Date: December 7, 2007

Subject: Design Change to Airflex Air Ride Suspension System

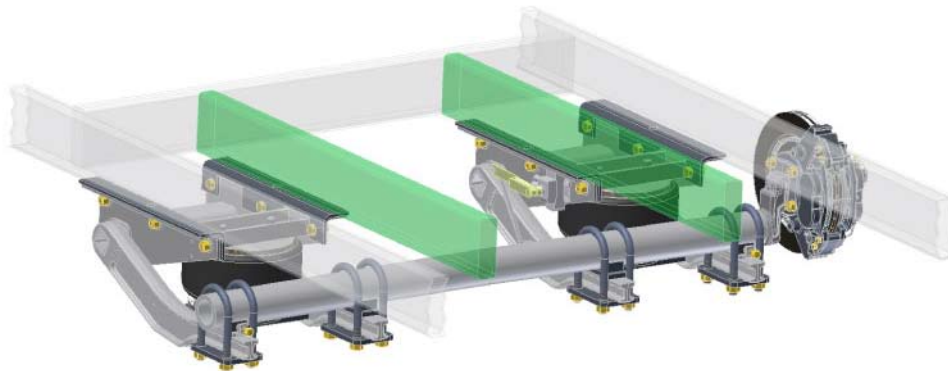
In keeping with our continual commitment to product quality and improvement, Dexter Axle is pleased to announce a design change to our Airflex Air Ride Suspension System. The updated version now has additional mounting flanges on the inboard side of each suspension assembly. This change greatly improves the strength and rigidity of the entire Airflex suspension system.

Important Note:
 The new inboard flanges will need to be attached to additional frame supports incorporated into the trailer frame as shown below. Refer to the installation instructions for additional frame member requirements.

- The mounting holes for the ride height control have been relocated and the valve orientation has changed to provide clearance.
- The U-bolts have increased in size from 5/8 diameter to 3/4 diameter and a new tie plate is used with the increased U-bolt size. Previous installations can be serviced with the new suspension assemblies provided there is clearance for the new inboard mounting flanges. The 5/8 U-bolts can be serviced with the 3/4 U-bolts in pairs with the new tie plate.
